PG&E Letter DCL-18-094  
PG&E Letter DIL-18-015

Docket No. 50-275, OL-DPR-80  
Docket No. 50-323, OL-DPR-82  
Diablo Canyon Units 1 and 2  
Docket No. 72-26, Materials License No. SNM-2511  
Diablo Canyon Independent Spent Fuel Storage Installation  
Emergency Plan Implementing Procedure Update

**Summary of the Analysis of Changes to  
Emergency Plan Implementing Procedure EP RB-3, Revision 9  
“Stable Iodine Thyroid Blocking”**

**Summary of the Analysis of Changes to  
Emergency Plan Implementing Procedure EP G-5, Revision 16  
“Evacuation of Non-Essential Site Personnel.”**

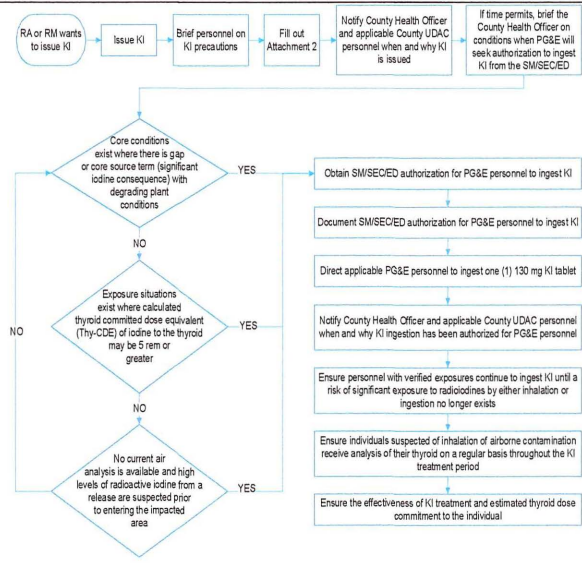
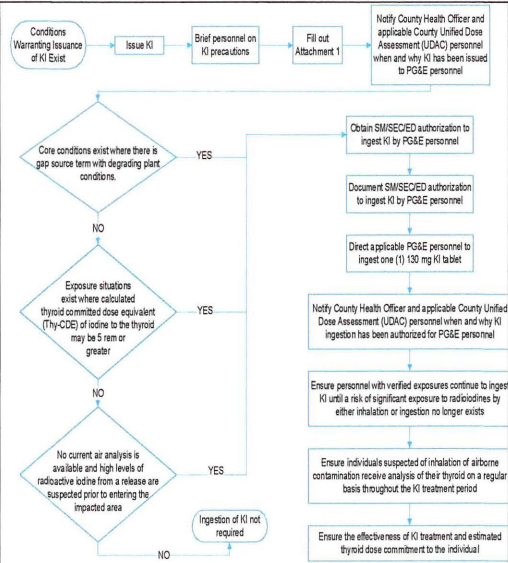
21

Modified content.

Revised the KI Process Flowchart to reflect the changes in this revision and to correct the logic error of not rechecking conditions after arriving at "Ingestion of KI not required."

**This change does not affect how the current E-Plan meets any planning standard functions, elements, or site-specific commitments. No additional evaluation required.**
